**TSI-04-13-04**

**Subject:** Eaton® Fuller® FR Series Transmission Shift Shaft Revision for Transmissions Built After August, 2000

TMIB-0142

## Topic: FR Series Shift Shaft Revision

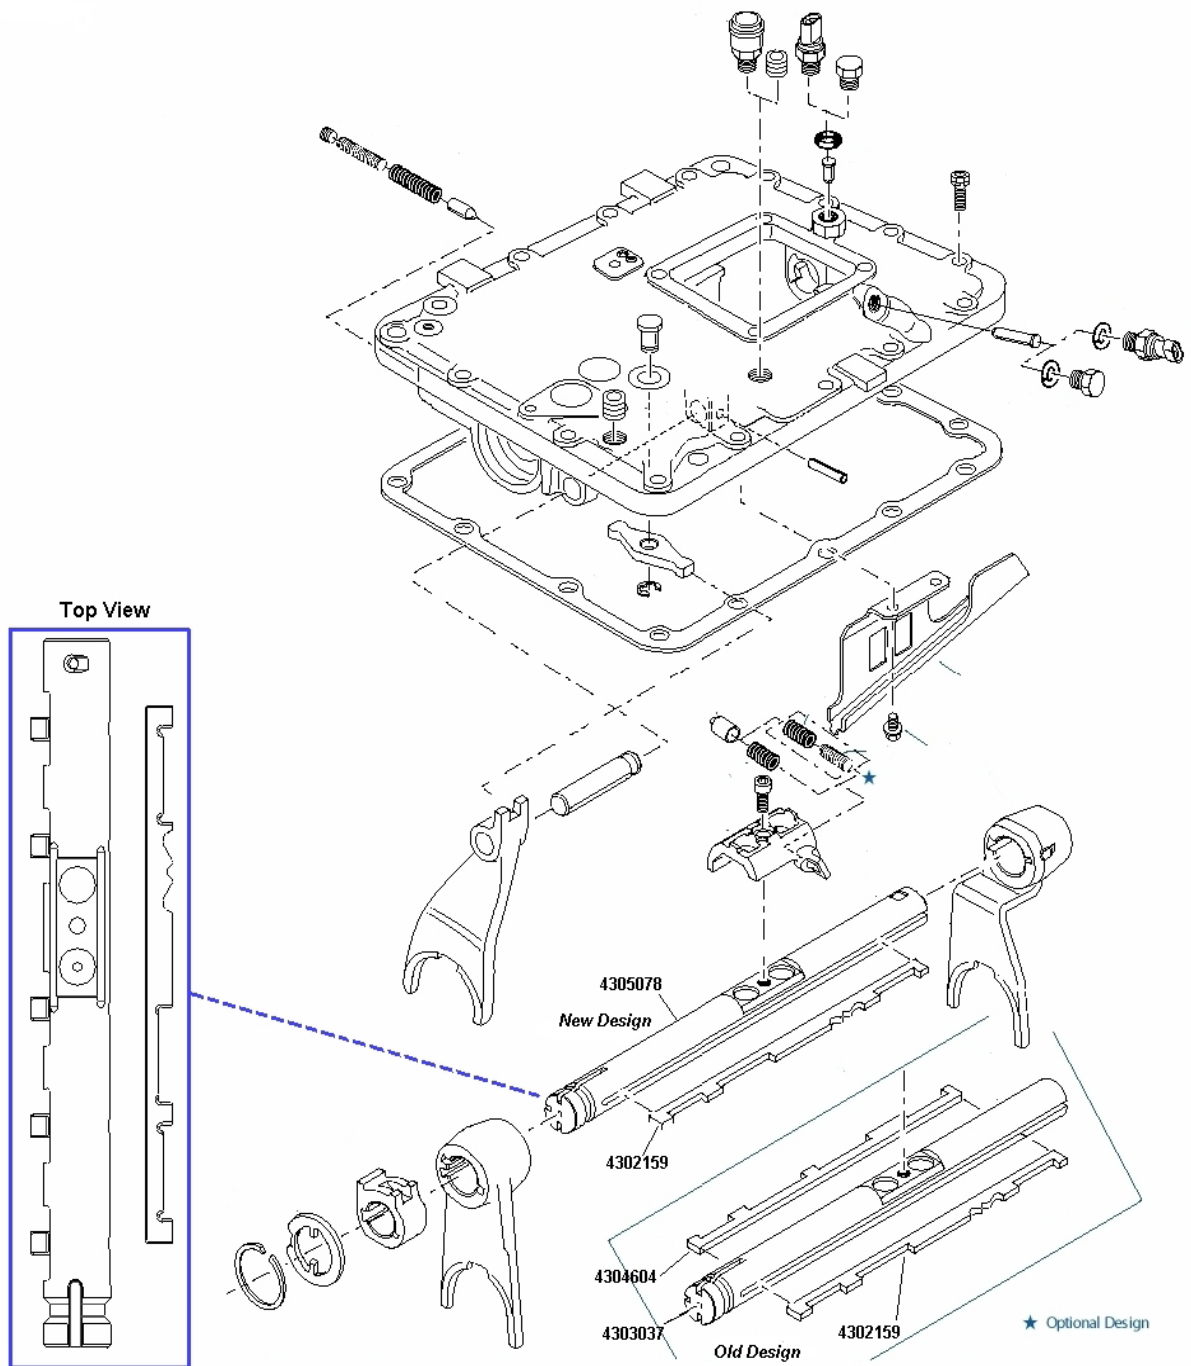
This bulletin is to provide clarification of an earlier update to this product. Complaints of broken shift interlock keys causing difficult shifting in or out of gear.

The shift shaft of the FR series was revised to improve reliability of the shift rail assembly. The new shaft design includes one interlock key and shift pins to replace the previous shift key.

The old design shift shaft may be used in either the new or old shift bar housing. The new design shift shaft with the revised shift pins may only be used in the new design shift bar housing.

August 2000. All transmissions built after this date will include the new design.
